Access Compliance Report

Public Rights-of-Way

(Curb Ramps)

Intersection ID: 4615	Main Street: CLAIREMORE_PL	Cross Street: TRINITY_RD	Location: SW
ADA ID: 9AFE0FCCB4B2	Ramp Type: Perp	Initial Pass/Fail: Fail	Overall Compliance: No
Severity Score: 22.5			
Codes/Mitigation Info/Possible Solution		Field Measurements/Component Compliance

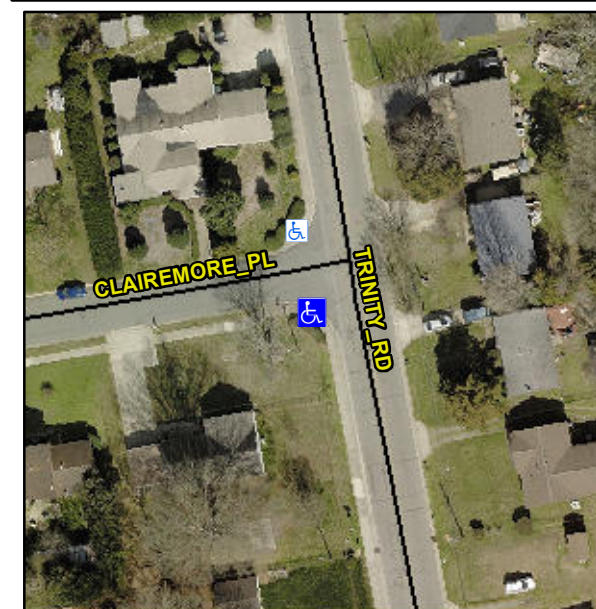
R304.5.1, R304.2.2, R304.5.3

Compliance	Description	Data	Compliance	Description	Data
N/A	Ramp Length (in)	58.0	No	Ramp Slope (%)	11.4
No	Ramp Width (in)	39.0	No	Ramp XSlope (%)	2.4
N/A	Flare Type LT	N/A	N/A	Flare Type RT	N/A
N/A	Flare Slope LT (%)	N/A	N/A	Flare Slope RT (%)	N/A
N/A	Flare Traversable LT?	N/A	N/A	Flare Traversable RT?	N/A
N/A	Landing Length (in)	N/A	N/A	DWS Provided?	N/A
N/A	Landing Width (in)	N/A	N/A	DWS Contrast?	N/A
N/A	Landing Slope (%)	N/A	N/A	DWS Length (in)	N/A
N/A	Landing X Slope (%)	N/A	N/A	DWS Full Width?	N/A
N/A	Landing Curb? (Y/N)	N/A	N/A	DWS Offset (in)	N/A
N/A	Shared Landing?	N/A			
N/A	Gutter Ponding?	N/A	N/A	Gutter Slope (%)	N/A
N/A	Gutter Lip Ht (in)	1.0	N/A	Gutter X Slope (%)	N/A
N/A	Painted X Walk1?	No	N/A	Painted X Walk2?	N/A
	X Walk 1 Direction	To N		X Walk 2 Direction	N/A
N/A	X Walk 1 Width (in)	N/A	N/A	X Walk 2 Width (in)	N/A
	X Walk 1 Slope (%)	2.4		X Walk 2 Slope (%)	N/A
	X Walk 1 X Slope (%)	1.6		X Walk 2 X Slope (%)	N/A

Remove & Replace Entire Ramp.
